THE BRAKE PAD PARTNERSHIP
Compilation of Technical Reviewers' and Stakeholders' Comments on
Watershed Modeling Draft Report
July 22, 2007

NOTE: Responses to comments are in Arial font.

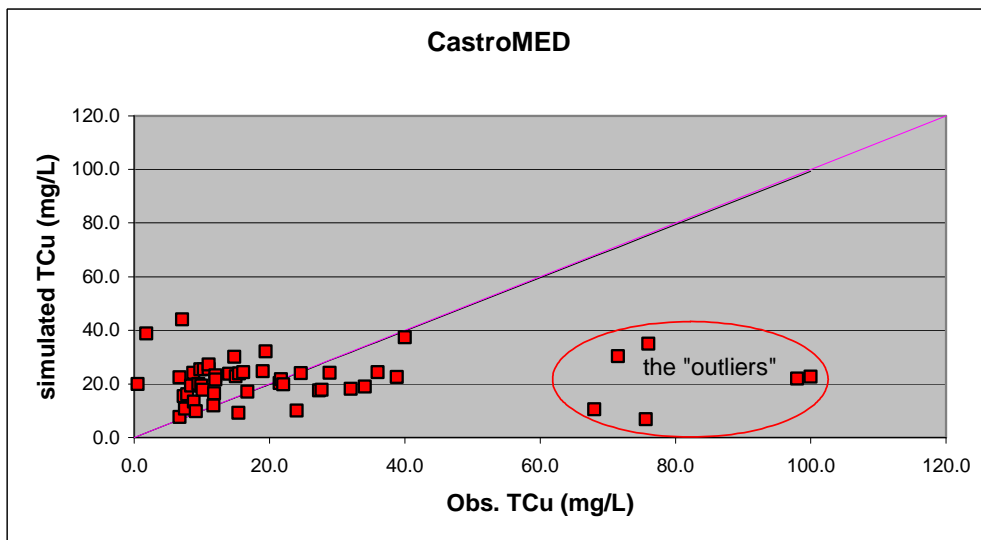
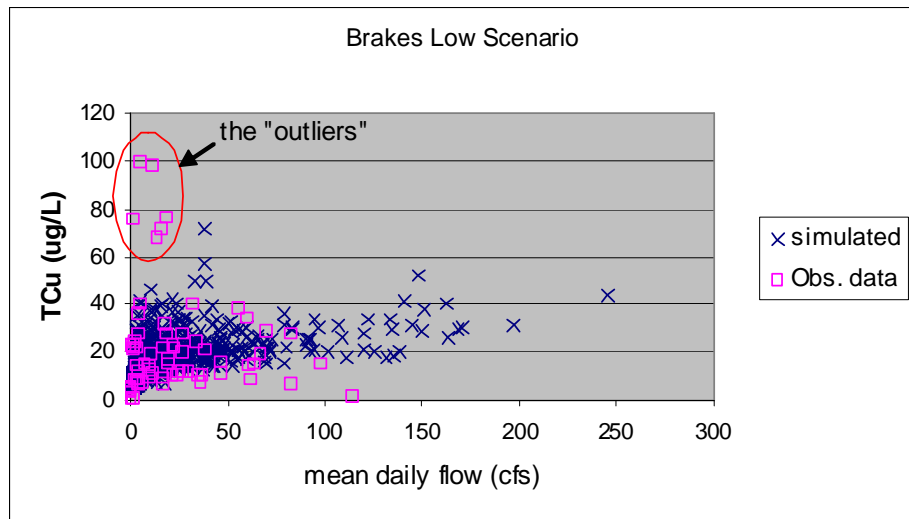
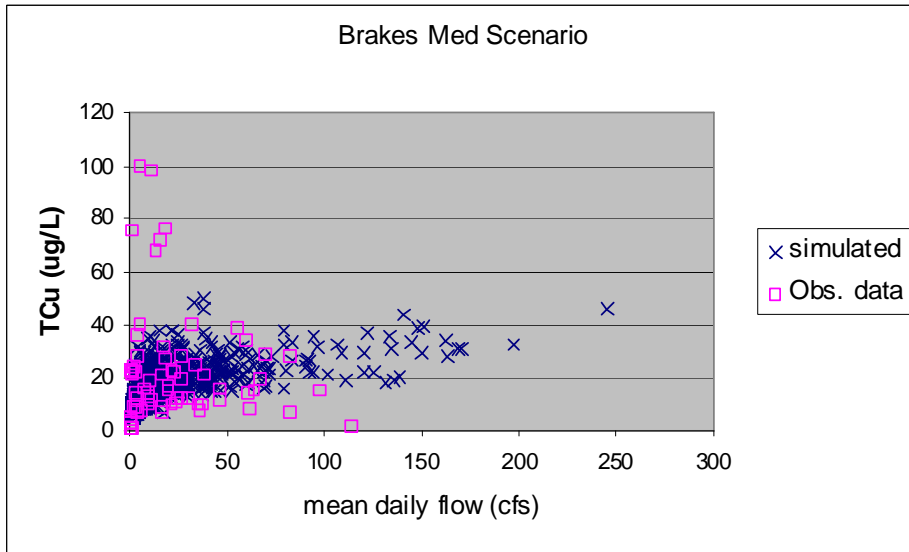
P31, Third paragraph, Last sentence: What reason do we give to consider these 6 points as outliers? An alternate hypothesis is that the model is missing a significant loading, because the observations are 4 to 5 times higher than the predicted values. I do suggest more text on this topic.

15. Is there a reason for dropping the six high observed Cu concentrations in Figure 3.4? Agreement between simulated and observed concentrations is not so good when they are retained.

Demonstrate the decision to throw out 6 of the data points is statistically valid; there are specific test to demonstrate this. Why 6, why not 5 or 7? If the data cannot be thrown out statistically they should be included.

Jim Carleton has done additional plots (attached) demonstrating that those 6 points correspond to lowflow conditions and can reasonably be considered outliers.

See responses to Jim Pendergast's questions, and attached plots.

MEAN ANNUAL COPPER FLUXES IN THE WATERSHED MODEL (1000 kg/yr)

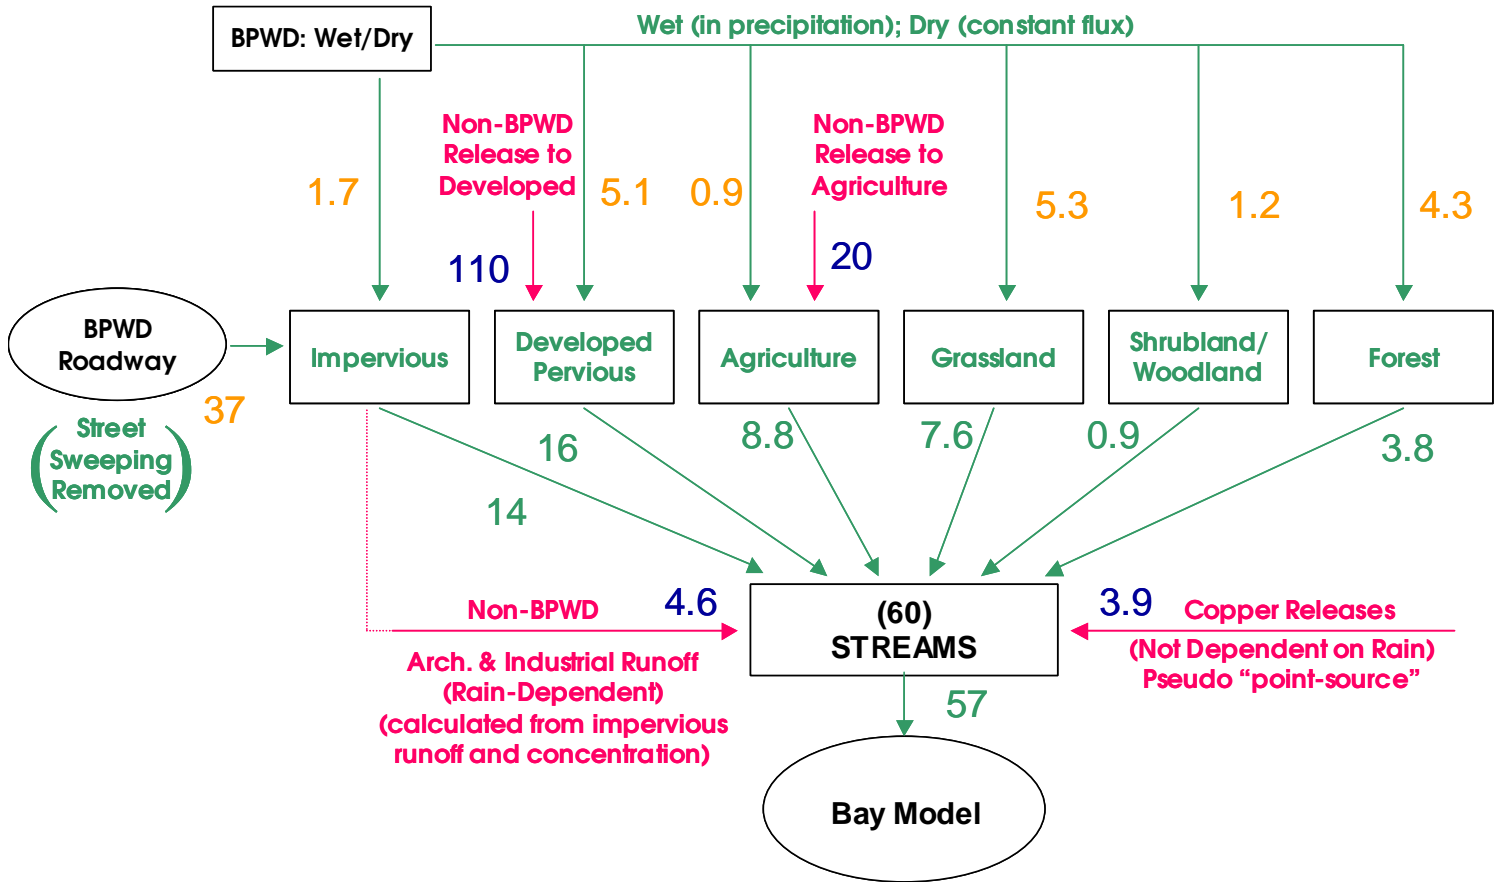
Figure 2.6 could use more work; I cannot put my hand on it, but it is not particularly useful in the present form.

That’s disappointing as it was well-received, after some further refinements, at the BPP Stakeholder Meeting. A copy of the figure with flux numbers is attached.
